SUPPLEMENTAL STAFF REPORT

RE: Case File No.: Zoning Ordinance Amendment 1-12, Section 143 Urban Center Zones. Proposed Zoning Ordinance text and map amendments to adopt and apply new urban center zones to the AmberGlen Community Plan area

AmberGlen Zones and Development Regulations

Planning Commission Public Hearing: ZOA 1-12

**John Olson Site, MU-C current/UC-MU proposed,
(Preliminary Concept Plans, 2012)**

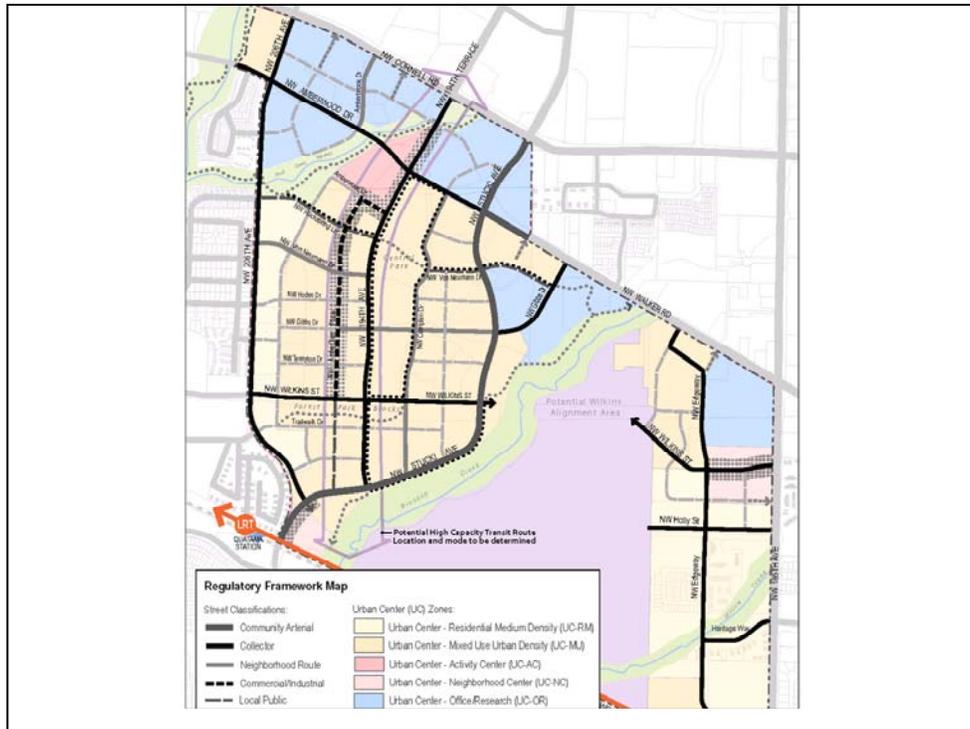
- Market currently supporting density of 55.2 du/net ac and 1.4 spaces/du parking ratio with no proximate HCT (planned), some urban retail within ½ mile
- Good street frontage coverage. Urban on the outside, suburban on the inside
- Surface parking area at 35% is close to current max (25%); However, parking overwhelms and somewhat degrades internal environment
- Green Access Lane helps to scale 5.3 acres and 229,385 gsf into two sites/buildings with pedestrian access lane and access to regional trail
- Dead-end lane not effective for providing grid to scale the development and pedestrian environment. UC zones would require local street (public or private) to break up 700' block length, connecting 206th to AmberWood Dr.

Conclusion: Densities exceeding 50 du/net acre are currently viable, but do not support costs for structured parking. Limiting surface parking area not as critical to accomplishing adopted urban vision as connectivity standards to impose a grid of pedestrian-scaled streets based on a 300' block length.

UC Connectivity Standards

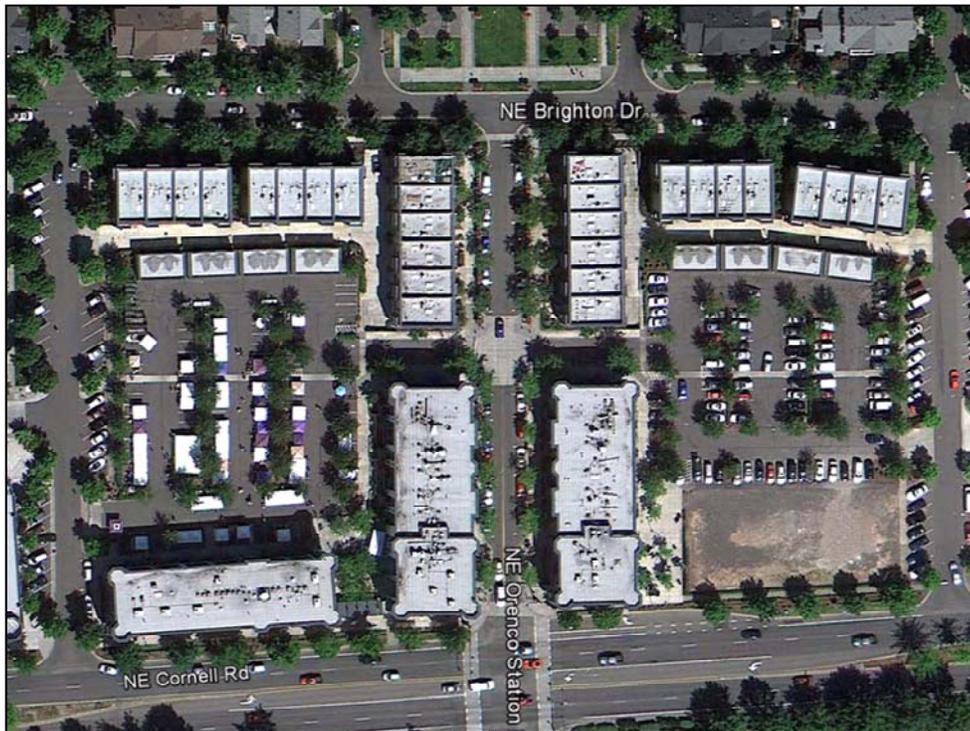
Illustration on right shows required streets and existing development for AmberGlen Plan area north of Wilkins Street and west of the planned Central Park:

- Development sites/blocks that exceed 300' will require a local street or green access lane connection. These required connections are not shown. If connection is not a public right-of-way, a public access easement is required.
- Front property line coverage applies at all streets.
- Development sites range from 0.8 acres to 4.0 acres.
- Illustrative Concept Plan on left demonstrates development on the 0.8 acre and 2.5 acre sites (UC-RM) located at NW 206th Avenue north of NW Wilkins Street.
